Model:	M24C				
A/C Reg:	G-CGPB	G-CGRT	G-CGRY	G-CGRZ	G-CGTI
	G-YROR	G-YRAX	G-PLOP	G-CGTK	
A/C SN:	24105964	24106044	2410613	4 241060	)04
	24106094	24116034	2411620	4 241162	214 24116194

#### SB TITLE – Rudder Pedal Block

Following an in-flight failure of the pilots rudder pedal mounting block (Part No. 514-05-25) a subsequent investigation concluded that the part failed due to an incorrectly machined fillet radius. The fillet radius had a sharp inclusion machined into the radius that significantly increased the stress at the base of the pivot boss that led to the part breaking after only 55 hours.

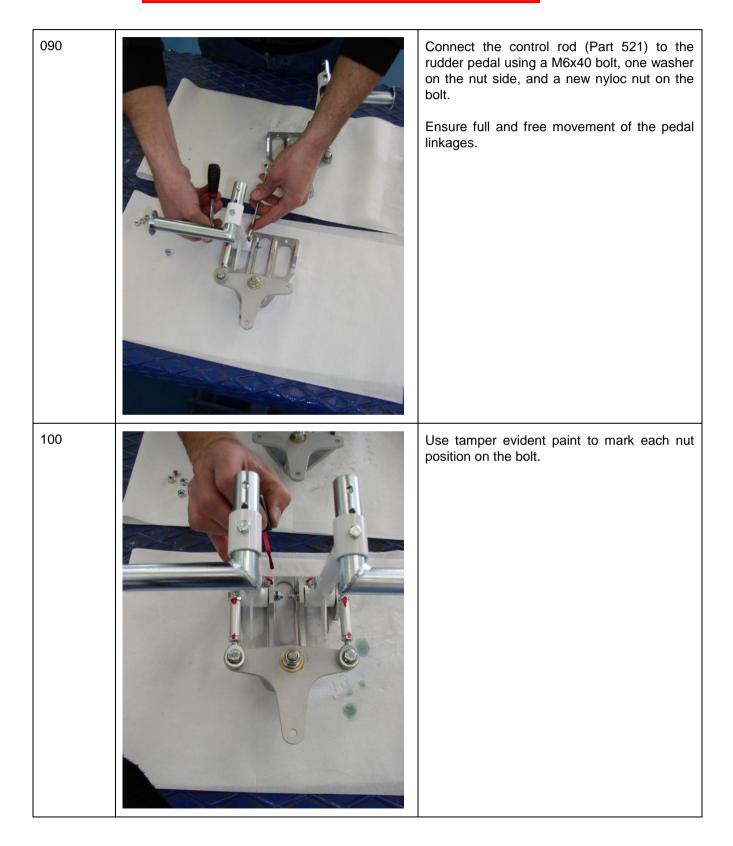
The resulting investigation concluded with the recommendation that all rudder pedal blocks fitted to the UK fleet should be replaced with a redesigned bracket before further flight is permitted.

This service bulletin defines the procedure to remove the two previous pedal blocks and replace both with the redesigned brackets.

070	Place the rudder pedals on the new pedal block using the M6x55 screw, one washer on the nut side, and a new nyloc nut.
080	Replace the control rod (part 521) on the new pedal block link, securing with the M6x25 bolt, one washer on the head side (under the rod end bearing), one washer on the nut side, and a new nyloc nut.

110	<image/>	Secure the rudder control block to the floor using the M5x16 bolts. Make sure to maintain position of the Velcro for the floor mat under the rudder pedals.
120		Secure the rudder control rod (part 522) to the pedal block link (Part 517) with the M6x25 bolt, one washer on the head side (under the rod end bearing), one washer on the nut side, and a new nyloc nut.
